# Broken Hill Battery Energy Storage System Project

Submissions Report

30-Jul-2021

Figure 1 Upstream catchment

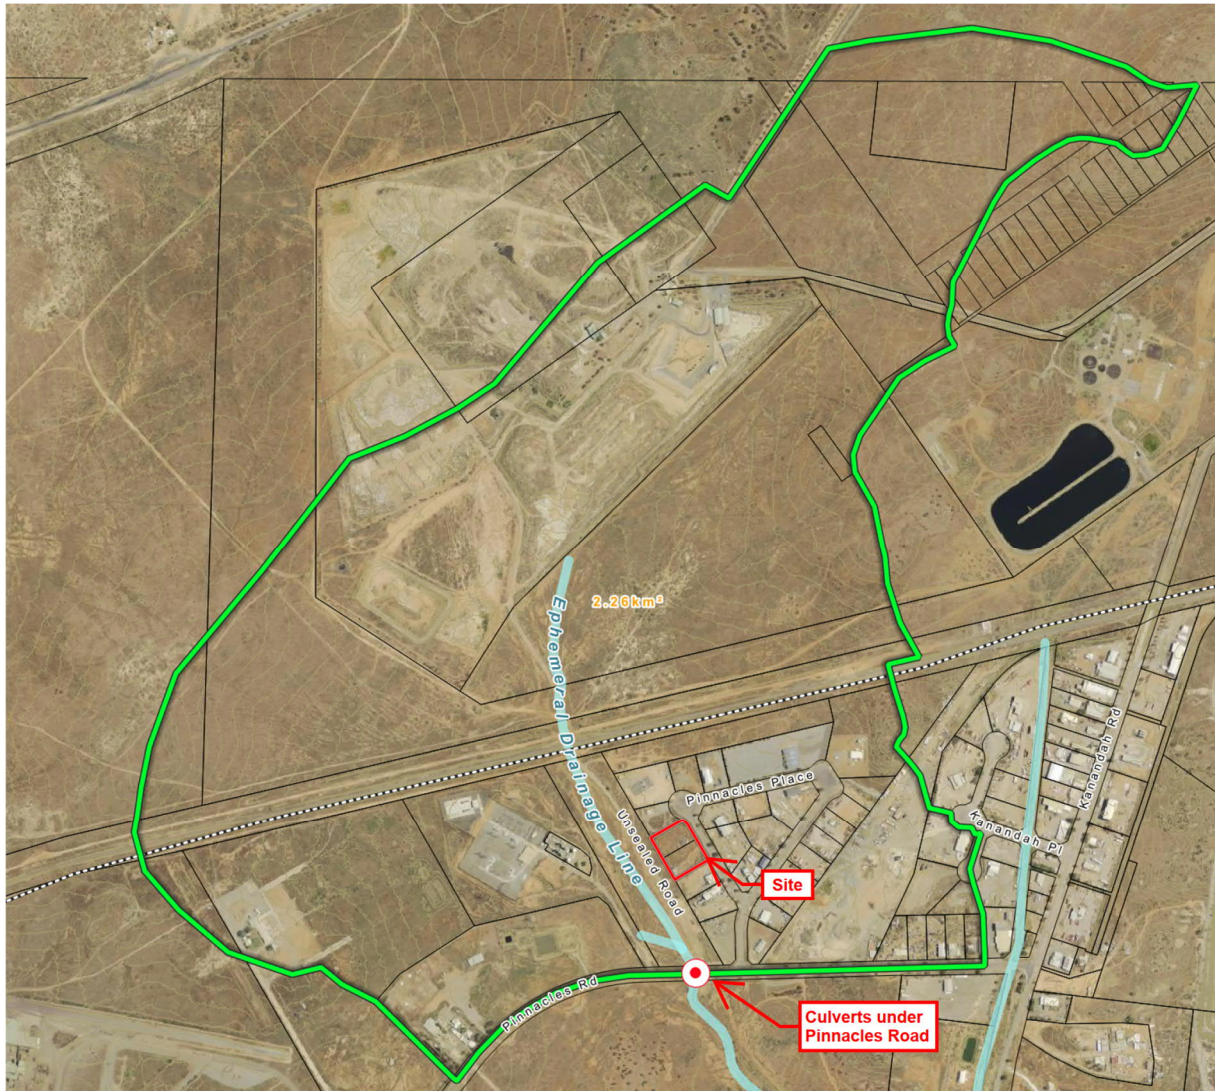
Submission	Response
<b>Issue 1. The qualitative flood risk assessment does not meet DPIE requirements</b>	
<p>BCD has reviewed the flooding component in Section 14.0 of the EIA (and Appendix G). DPIE has noted that the EIS does not fully address the Secretary's requirements for flooding. The EIS (Chapter 14.0 – Surface water, flooding and water use &amp; Appendix G – Surface water assessment) also does not address the BCD environmental assessment required related to flooding.</p> <p>A simple hydrological assessment has been completed that examines the overland flow-related flooding that would occur during high intensity rainfall events originating within the industrial subdivision. However, no assessment seems to have been undertaken of the flows residing in the adjacent ephemeral flow path (that runs adjacent to the site). It is possible that any overland flow event could coincide with a flow emanating in this ephemeral flow path due to the relatively small upstream catchment, which may impact the site. The flood liability of the proposed development site remains unknown until the flows from these catchments are hydraulically modelled to determine the extent, depths and velocities of the design flood events.</p> <p>Note that this additional modelling does not have to encompass a complex fully 2-D hydraulic model. It could be a simple 1-D approach that includes the major drainage lines, most crucially the ephemeral drainage line, that allows for the mapping of the major design flood events. It will also allow for the flood liability of the site to be determined and the impacts resulting from the development (internal and external to the site) to be determined.</p>	<p>A one-dimensional (1D) hydraulic model has been developed to assess the flood extents, depths and levels along the ephemeral drainage line. This has been undertaken to determine whether the Site would be impacted by floodwaters along the ephemeral drainage line in a 1% AEP storm event. The adopted modelling approach and modelled results are provided in <b>Appendix A</b>.</p> <p>The modelling results indicated that the Site would not be impacted by flooding along the ephemeral drainage line in a 1% AEP event. The Site can achieve at least 0.40 m freeboard to the 1% AEP flood levels, based on existing surface levels along the western boundary of the Site. A larger amount of freeboard would be achieved at higher levels within the Site and for important infrastructure set above the existing ground level.</p> <p>On this basis, surface water runoff generated by the Site would be able to freely drain to the ephemeral drainage line, noting that the timing of peak discharge from the Site would not coincide with the timing of peak flows along the ephemeral drainage line. Therefore, when peak flows discharge from the Site, water surface levels within the ephemeral drainage line would be significantly lower.</p> <p>A sensitivity analysis, allowing for culvert blockage, increased flows and increased tailwater conditions, has also been undertaken. Under these more extreme/conservative conditions, the Site would still not be impacted by the 1% AEP floodwaters moving along the ephemeral drainage line.</p>

There is large upstream catchment, in the order of 2.26 km<sup>2</sup>, that contributes to flow along the ephemeral drainage line as moves past the Site. This catchment is shown in Figure 1.

The calculations indicated that the large upstream catchment would generate a peak flow rate in the order of 15.2 m<sup>3</sup>/s in a 1% AEP storm event. These calculations are provided as an attachment.

**Vegetation zones and plot locations**  
 Broken Hill Battery Storage BDAR

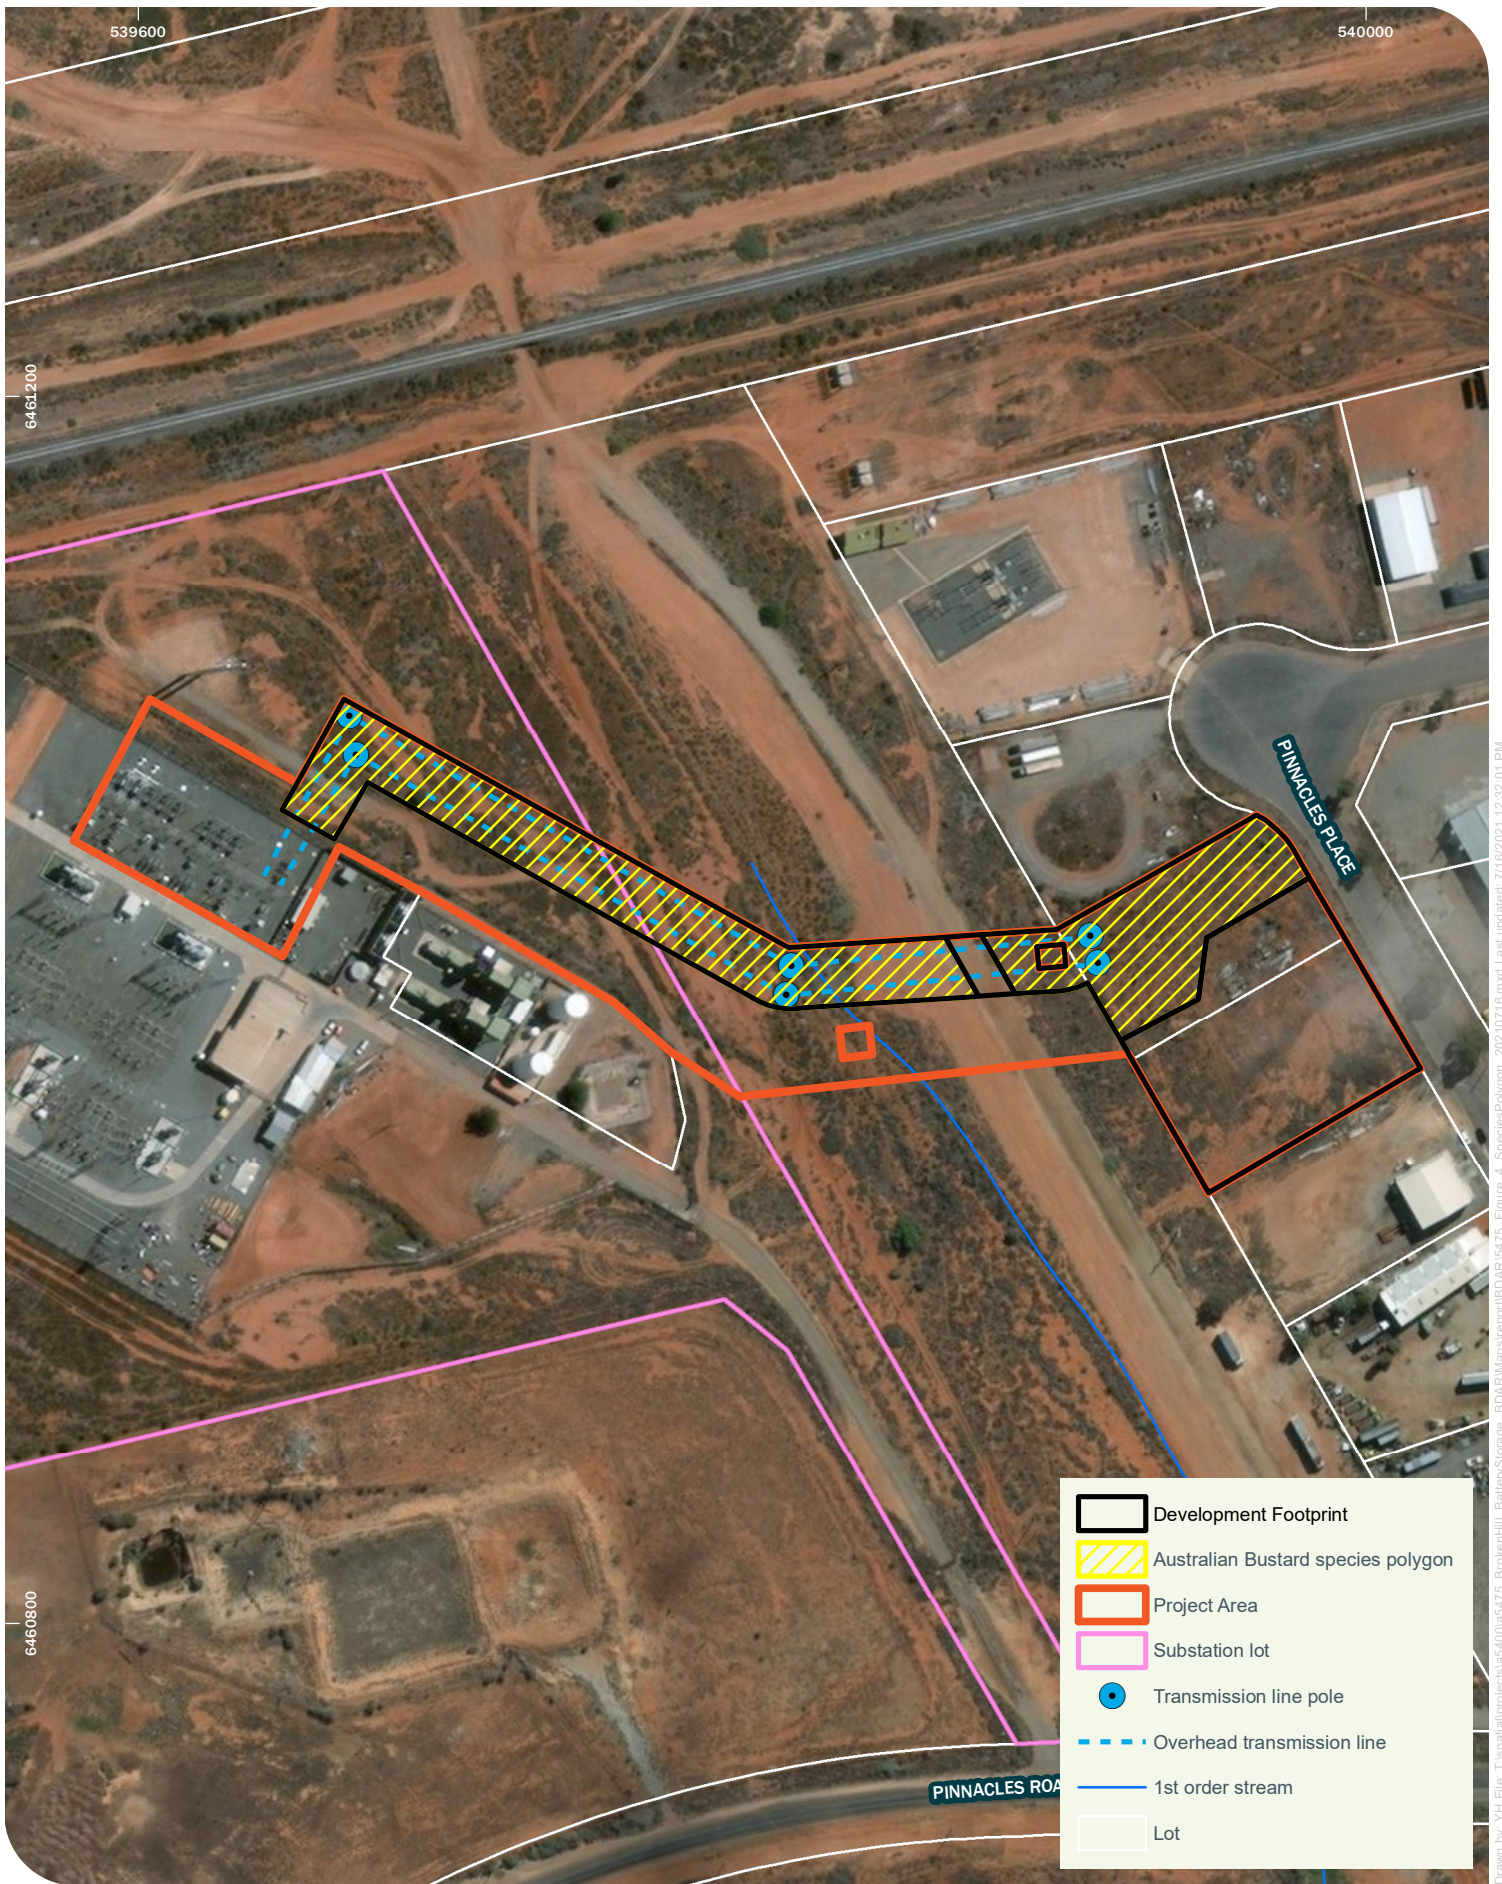
<p>Information about assessed vegetation zones is missing from the BDAR. The native vegetation assessment results in Table 7 (page 15) are limited to the development footprint.</p> <p>The BDAR should include a table summarising all native vegetation mapped on the subject land ('project area' in the BDAR) indicating the required number of plots. The survey effort and intent of the plot-based vegetation survey is to identify the PCTs (BAM 2017, cl. 5.2.1.4).</p> <p>The plot based survey must be stratified and targeted to assess the expected environmental variation (BAM 2017, cl. 5.2.1.7), which means both the mapped condition states for PCT 155 should be adequately sampled.</p> <p>The data for PCT 155 mapped as 'moderate' condition should be included in the BDAR and BAM-C. Vegetation zones in BAM-C and the BDAR should match the spatial data for zones clipped to the subject land boundary (datasets dated 2020 May 2021).</p>	<p>There is a single native vegetation zone that would be impacted by clearing, which is described within the BDAR (refer to section 4.2), with other vegetation zones added to the figure for context (refer to Figure 3 in <b>Appendix B</b>).</p> <p>The development footprint was refined following survey work, with consideration to avoidance of impacts, which is why some plots are outside the development footprint. Data from plots representing zones that are not within the development footprint cannot be added to the BAM-C due to the requirement for an area of clearing to be nominated which is not appropriate for areas that will not be cleared.</p> <p>A single plot (Plot 3) was conducted within the development footprint. No updates have been made to Table 7, as only PCT 155 low condition is proposed to be affected (i.e. this PCT is within the development footprint). BAM plot numbers have been added to Figure 3 (refer to <b>Appendix B</b>). BAM Plot data for plots 1 to 4 were sent as an excel spreadsheet to DPIE on 15 June 2021.</p>

Submission			Response
<b>GIS label</b>	<b>PCT ID</b>	<b>Area (ha)</b>	
Bluebush shrubland – low condition	155	2.63	
Bluebush shrubland – moderate condition	155	0.06	
Exotic	0	0.54	
<p>While it is not critical for DPIE’s review of a simple development site such as this, the BDAR and spatial data should include the BAM-C vegetation zone identified to enable cross-checking (e.g. Zone 1).</p> <p><b>Recommended action:</b></p> <ul style="list-style-type: none"> <li>Table 7 to include the area vegetation zone in the project area (mapped in <b>Figure 3</b>).</li> </ul>			
<p>More evidence is needed to justify use of BAM Plot 3 to represent the assessed vegetation zone #1 (PCT 155 low condition).</p> <p>The area around BAM Plot 3 does not appear to be representative of the vegetation to be impacted by the transmission connection on the adjacent Crown land (Lot 7302, DP1181129).</p> <p>BAM plot numbers should be included on the vegetation zones map for cross-checking.</p> <p>The Broken Hill aerial imagery available to BCD was captured in 2013 (figure A.1). Aerial imagery from 2021 available on Google Maps has also been reviewed (figure A.2) and shows the difference in vegetation pattern between Lots 57 and 58 and the Crown land traversed by the proposed transmission line (particularly within the blue line).</p> <p><b>Recommended actions:</b></p> <ul style="list-style-type: none"> <li>BAM plot numbers to be included on <b>Figure 3</b> (matching plot numbers in Annex 2 and spatial data).</li> </ul>			<p>A total of four plots were undertaken during surveys for the BDAR (Niche, 2021). Data from one of these plots (Plot 3), which is within the Site, was added to the BAM-calculator as this was considered the most representative of areas impacted by vegetation clearing.</p> <p>Given the disturbed nature of the disturbance footprint, which is evident from supplied aerial photography (Figure 1 in Appendix B), it is considered that this plot (which was used for condition scoring) was located conservatively. It was considered conservatively located as it was located within an area that allowed for the full length of the plot to be accommodated without cleared tracks intervening.</p> <p>The plots undertaken as part of the BDAR are consistent with the BAM requirement. All plot data are provided within Annex 1 of the BDAR (Niche, 2021). When other plot data for low condition areas are considered and compared with the selected plot, it is evident that the selected plot is representative. Plot 3 was chosen as it is within the development footprint. Other plots (Plots 1, 2 and 4) were not located within the development footprint.</p>

Submission	Response
<ul style="list-style-type: none"> <li>Provide more evidence to justify use of BAM Plot 3 to represent the assessed vegetation zone #1 (PCT low condition).</li> </ul>	<p>The development footprint was refined following survey work, with consideration to avoidance of impacts, which is why some plots are outside the development footprint.</p> <p><b>Figure 3</b> (refer to <b>Appendix B</b>) showing the vegetation zones has been updated to include plot numbers as per Annex 2.</p>
<p>Justification is needed for exclusion of species credit species from the assessment.</p> <p><i>Swainsona murrayana</i> was surveyed outside the specified survey months. The survey guidelines for threatened species described circumstances when the required survey season for threatened plant survey may be adjusted. However, any alteration to survey timing must be agreed with DPIE before the BDAR is submitted.</p> <p>An opportunistic fauna survey as described in Section 3.2.2 and Table 12 (page 22) is inadequate for demonstrating presence or absence of species credit species.</p> <p>Crowned Gecko (<i>Lucasium stenodactylum</i>) does not have a specified habitat constraints in BioNet. Further justification is needed for excluding this species from the assessment, according to BAM s.6.4 Steps 3 and 4, including description of habitat requirements and evidence from the field assessment that these components of the vegetation are degraded.</p> <p><b>Recommended actions</b></p> <p>Provide further justification for removal of Crowned Gecko and <i>Swainsona murrayana</i> from the assessment.</p> <p>Revise offset requirements in Section 5 (page 31) based on any resulting changes to the BAM calculator case.</p>	<p><i>Swainsona murrayana</i></p> <p>A survey was conducted in October 2020 to determine the presence of <i>Swainsona murrayana</i> (Slender Darling-pea) within the Project Area. A single survey month for the species is provided within the BAM-C (September). However, this does not appear to reflect the species profile, which states that plants produce winter-spring growth, flower in spring to early summer and then die back after flowering. They re-shoot readily and often carpet the landscape after good cool-season rains. A review of current information in NSW for this species (NSW Scientific Committee 2008) states that the flowering period of <i>Swainsona murrayana</i> is from August to November. Furthermore, this document contains location and record data, with 13 sites detecting the species in October (between 1956 and 2001). One of these sites recorded 3000 plants in October 2000.</p> <p>The BDAR (Niche, 2021) provided a justification for the suitability of the survey period, which included:</p> <ul style="list-style-type: none"> <li>Survey outside specified months; however, the species is known to flower in spring to early summer.</li> <li>Low – marginal habitat is present within better condition areas of the study area only, which have been avoided through Project design/site selection. This species was not detected during targeted searches in October 2020.</li> <li>The closest record of <i>Swainsona murrayana</i> is from Silverton (approximately 23 km to the north-west) from 1947.</li> <li>The approved conservation advice for the species states: Slender Darling-pea is found in grassland, herbland, and open Black-box woodland, often in depressions (DSE, 2001; Harden, 2002; DECC,</li> </ul>
